Drury Quarry Sutton Block – Comments Tracker – 17 September 2025

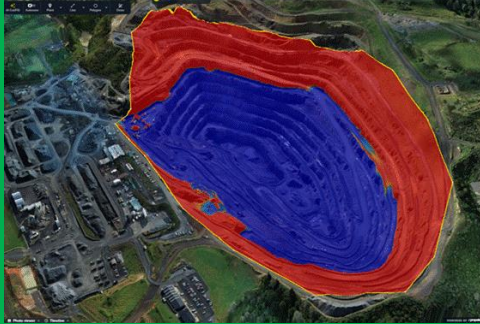
No.	Name (Lead)	Specialism	S67 Comments	Site visit Required	Preliminary Comments Provided	Preliminary Comments	Applicants response	Council comments 25.8.25 & 01.9.25	Applicant's response 17 September 2025
							groundwater barriers along the wetland's northern edge to mitigate dewatering of this wetland (refer to Section 9.3.2 of AEE report). In addition, shallow groundwater within and outside the quarry catchments will be monitored using 10 shallow piezometers (as outlined in Proposed Conditions Appendix 1: Schedule A Groundwater Monitoring Bores and Trigger Levels) to identify and mitigate any potential adverse effects on shallow groundwater and associated wetlands.		
61	Andrew Rossaak (Morphum)	Freshwater and Terrestrial Ecology	<u>Offsets</u> There is uncertainty that the offsets are possible and meet additionality. Request evidence that the proposed offset sites are consistent with the additionality concept (eg. Letter from te Waikato River Authority and Hingaia Island has capacity as there are already numerous offsets consented at this location).	YES	No		Refer to Table 3, REAR-TE (Technical Report C) confirms no other parties have planned or committed to the proposed revegetation or enhancement actions at either offset sites: Tuakau Site: Owned by Stevenson Aggregates Limited (Section 2.2.1.1.3, REAR-TE), with full control over proposed works. Hingaia Island: Identified through iwi consultation as a priority for full revegetation (and with consideration to existing offset commitments for which we have coordinated with DoC and iwi on). Both sites therefore meet the additionality criterion, with documented ownership, absence of overlapping projects, and alignment with national biodiversity offsetting principles.	It is understood that Hingaia has been removed from the offset package. No additional information has been provided on how the removal of offset that would have been located in Hingaia is to be addressed.	Refer to the Hingaia (Drury) Island Offset Revegetation Update dated 14 August 2025 attached as Attachment F.
